2nd Further Information

**Proposed Temporary Warehouse (Excluding Dangerous Goods Godown) with Ancillary Facilities
for a Period of 3 Years and Associated Filling of Land and Pond in "Agriculture" Zone,
Various Lots in D.D. 107 and Adjoining Government Land, Fung Kat Heung, Yuen Long**

(S.16 Planning Application No. A/YL-KTN/1024)

Responses-to-Comments

DRAWING TITLE
FS NOTES, LEGEND, ABBREVIATIONS AND DRAWING LIST

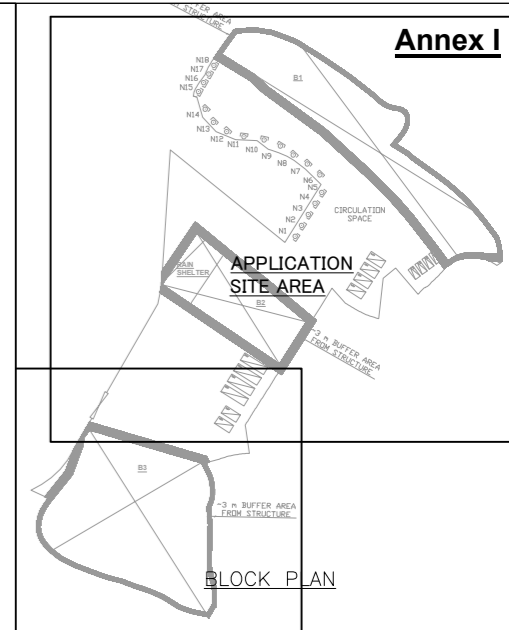
(a)	<p>Based on the submitted FSI proposal, I have the following comments:</p> <p>(i) FS Notes item 4.2 is considered irrelevant and shall be deleted; and</p> <p>(ii) The standards and specification of the proposed directional and exit signs shall be revised to 'BS 5266-1:2016 and the FSD Circular Letter No. 5/2008'.</p>	<p>Noted and revised accordingly. Please refer to the revised fire service installations (FSIs) proposal for details (Annex I).</p>

Title
DRAINAGE LAYOUT PLAN

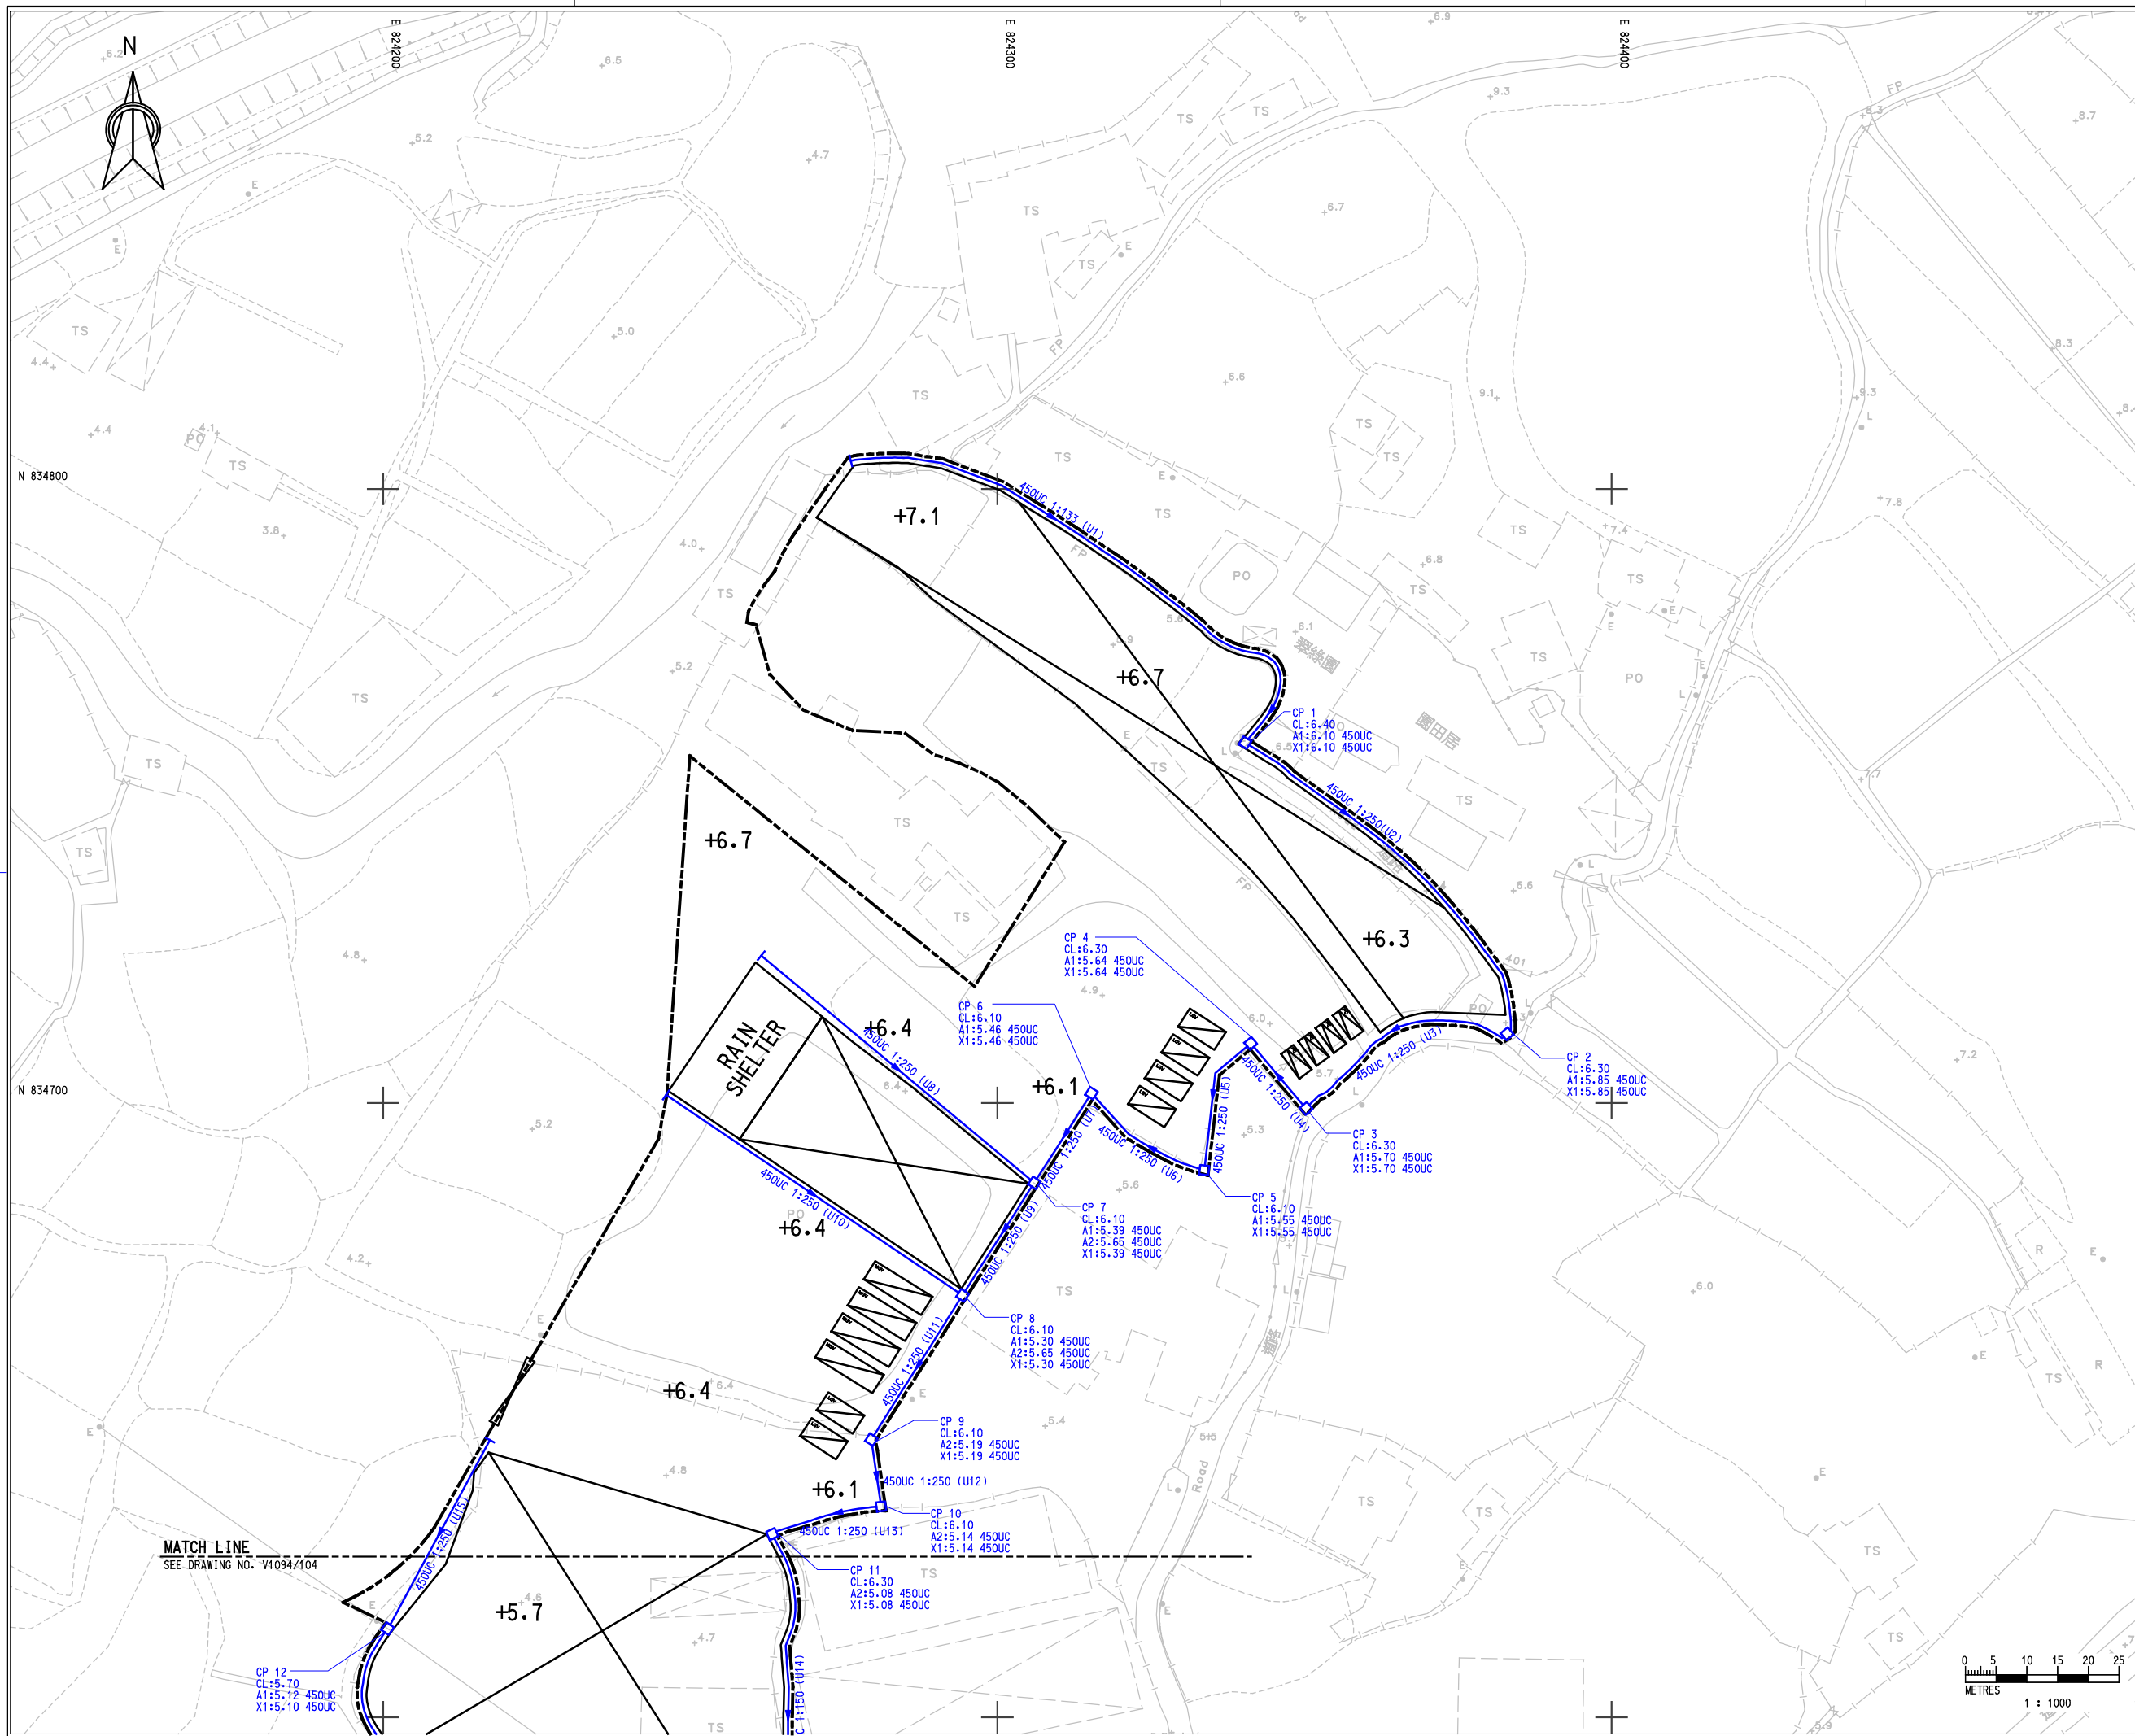
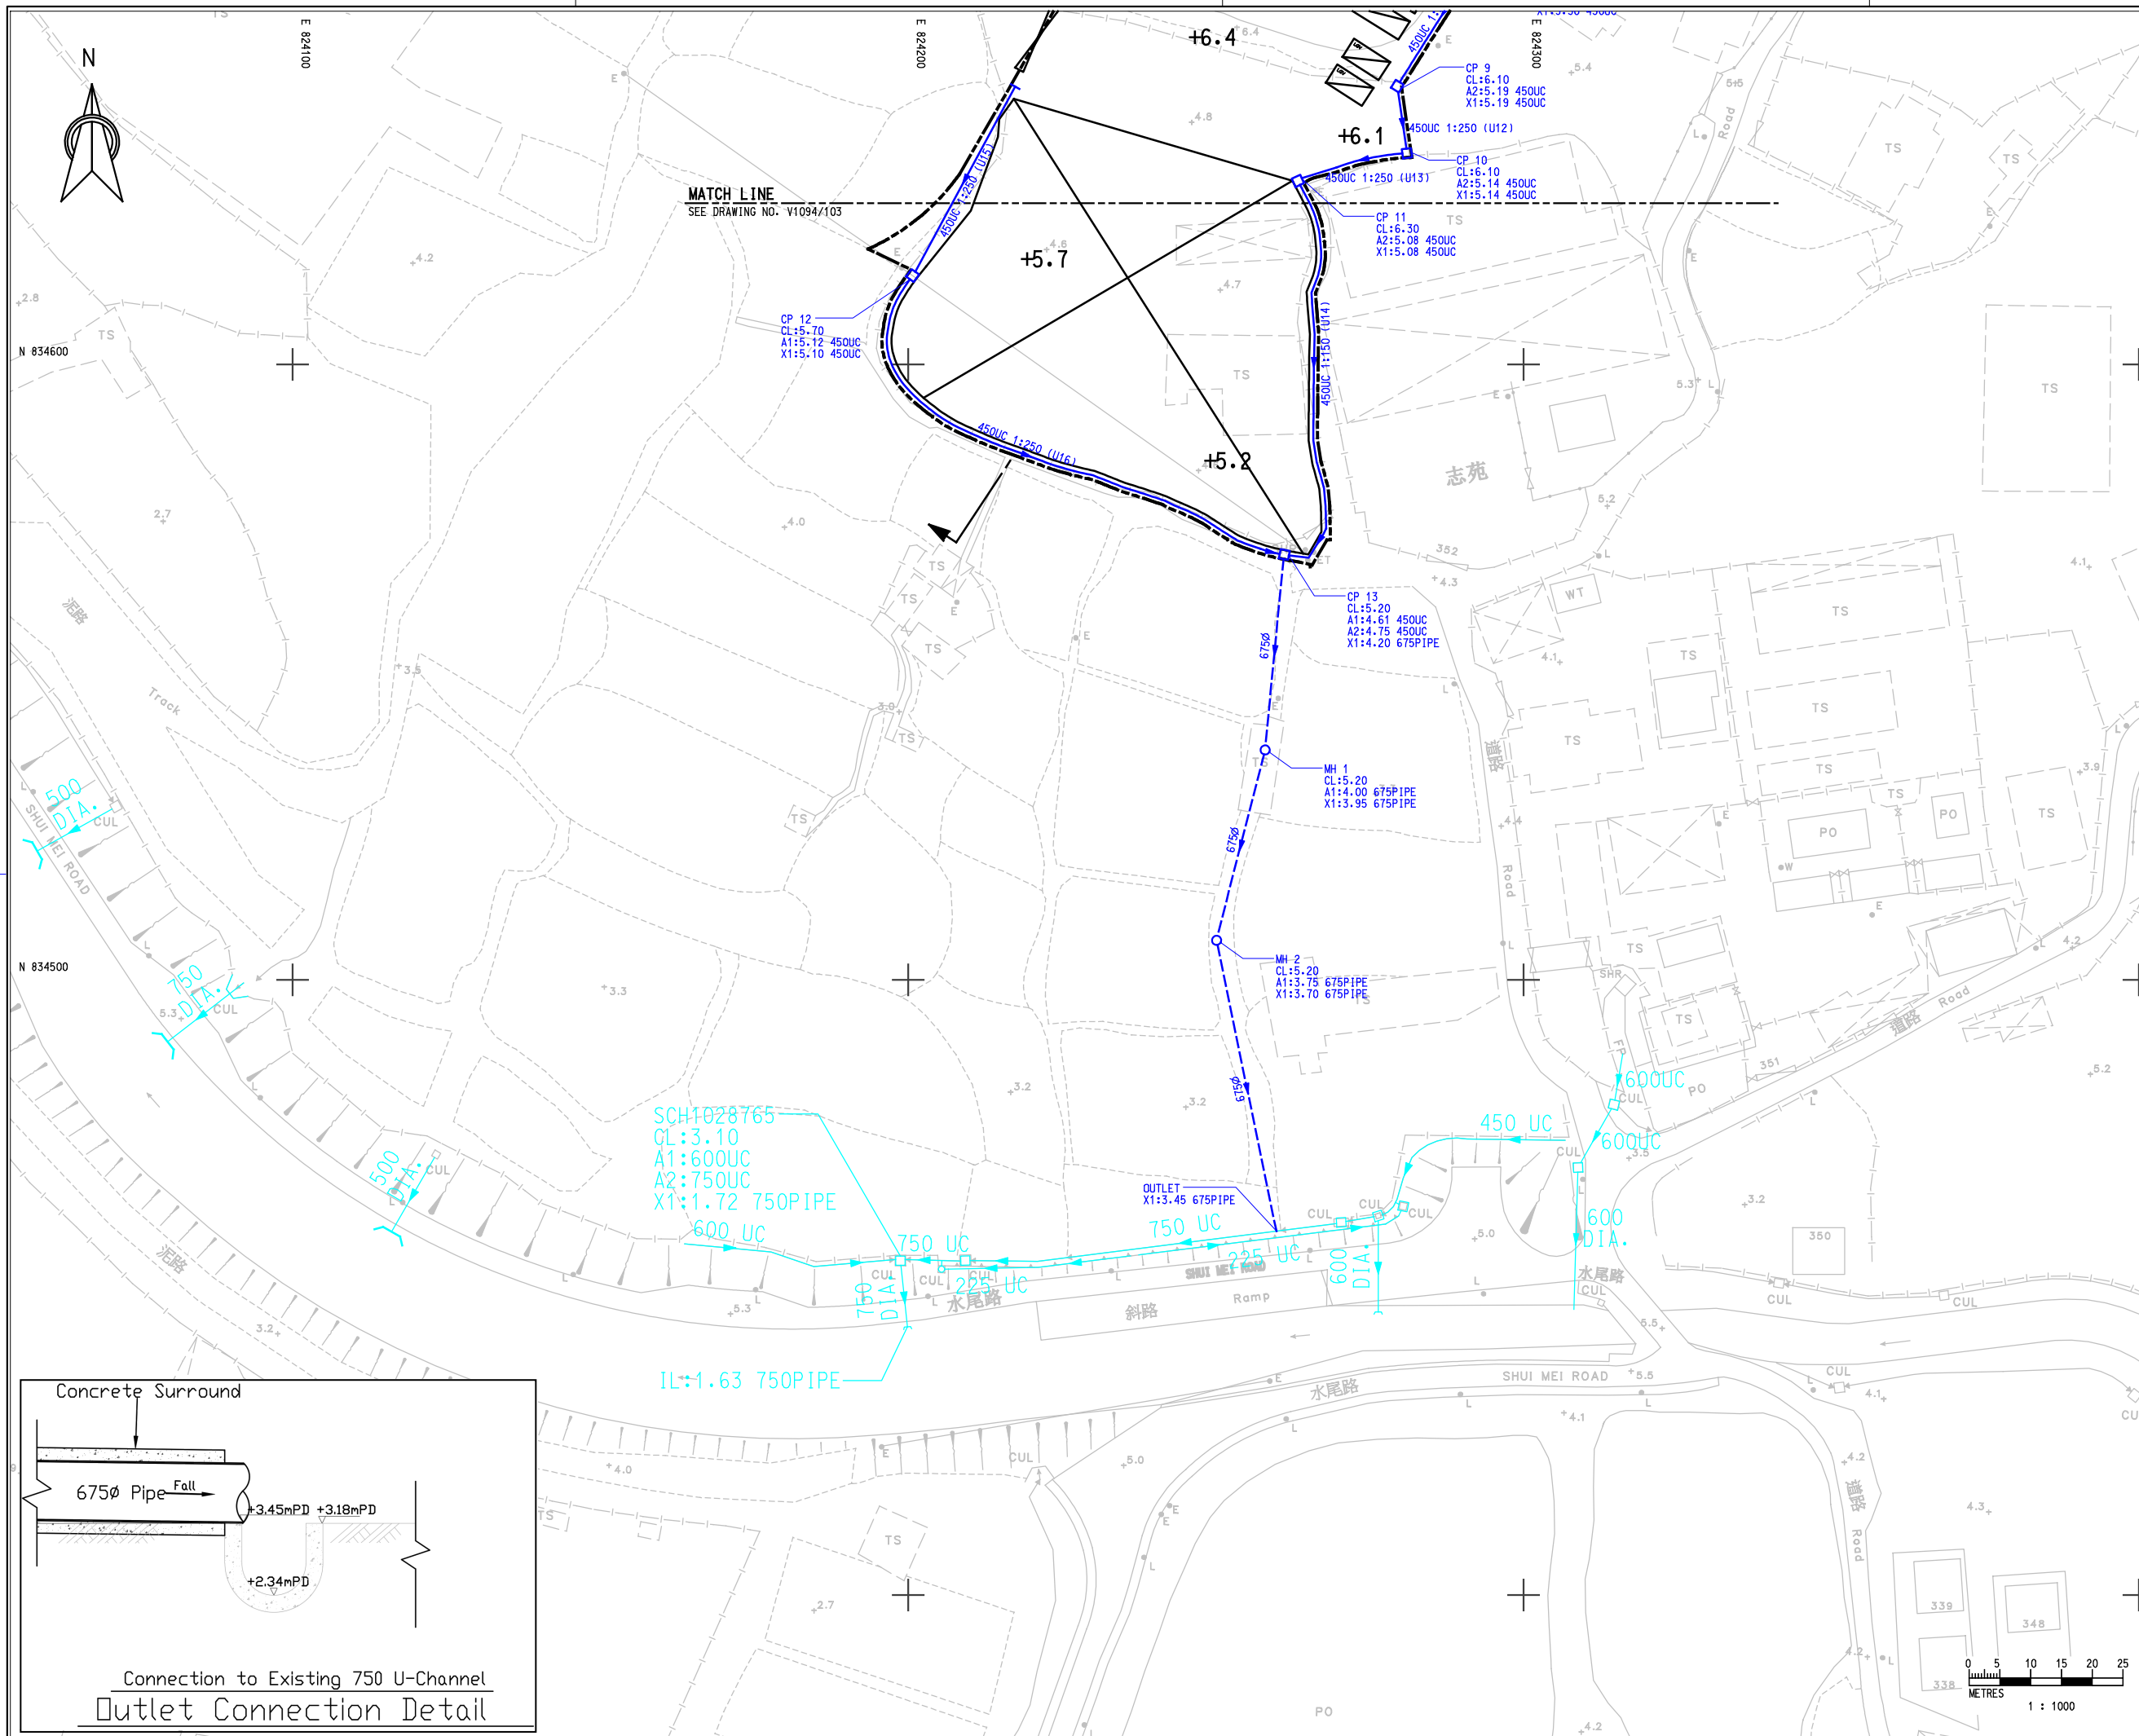
2. Comments of the Chief Engineer/Mainland North, Drainage Services Department (CE/MN, DSD) (Contact Person: Mr. Terence TANG; Tel.: 2300 1257)		
(a)	<p>The DIA should be signed and certified by a qualified engineer (Registered Professional Engineer in the Civil Engineering discipline) before it is submitted to DSD for comment.</p>	<p>A revised drainage impact assessment report, which signed and certified by the qualified engineer, has been submitted by the applicant to review the drainage arrangements for the proposed development (Annex II).</p>

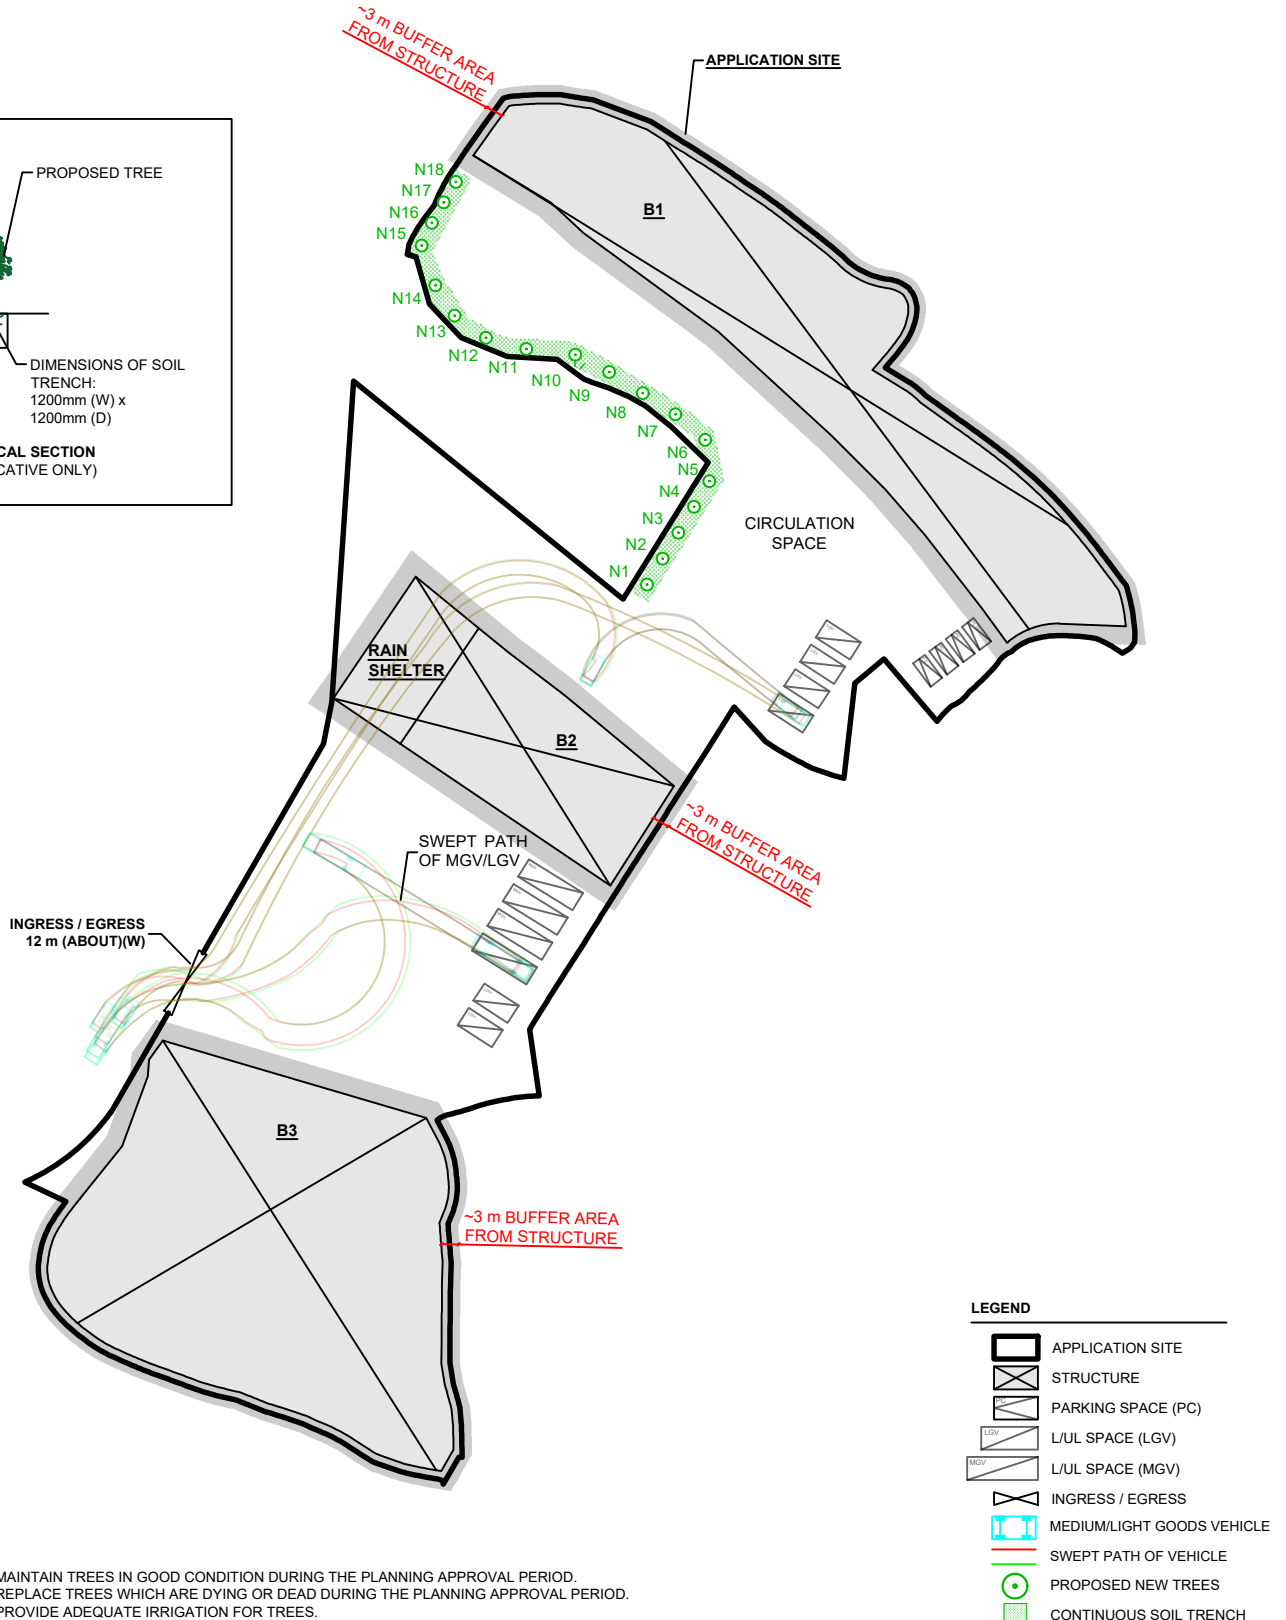
(a)	<p>Having reviewed the Further Information, it is noted that the filling material within the Site is partly revised from concrete to soil. 18 nos. of new trees are proposed along the northwest site boundary within the Site. Please find our comments from landscape planning perspective:</p>

<p><u>Landscape Proposal (ver.001) (Annex IV)</u></p> <p>i. Considering the species proposed (<i>Ficus microcarpa</i>) is large tree species that can grow up to approx. 25m high with wide crown spread and aggressive roots. The applicant is advised to revise the proposed species to small tree species to suit the site context.</p> <p>ii. The applicant is advised to revise the individual tree pits proposed to a continuous soil trench to facilitate growing of tree as far as possible. Relevant description and dimension should be reviewed.</p>	<p>A revised landscape proposal has been submitted by the applicant to provide landscape mitigation measure for the proposed development (Annex III). A total of <u>18</u> Small tree species (i.e. <i>Polyspora Axillaris</i>), with continuous soil trench, are proposed to be planted along the northwest portion of the application site (the Site) as a landscape buffer to the surrounding areas. All these new trees within the Site will be maintained by the applicant during the planning approval period.</p>

NO. OF NEW TREES WILL BE PLANTED	: 18 (N1 TO N18)
SPECIES OF NEW TREES	: POLYSPORA AXILLARIS
HEIGHT OF NEW TREES	: NO LESS THAN 2.75 m
SPACING OF NEW TREES	: NOT LESS THAN 4 m
DIMENSION OF TREE PITS	: 1.2 m (W) X 1.2 m (D)
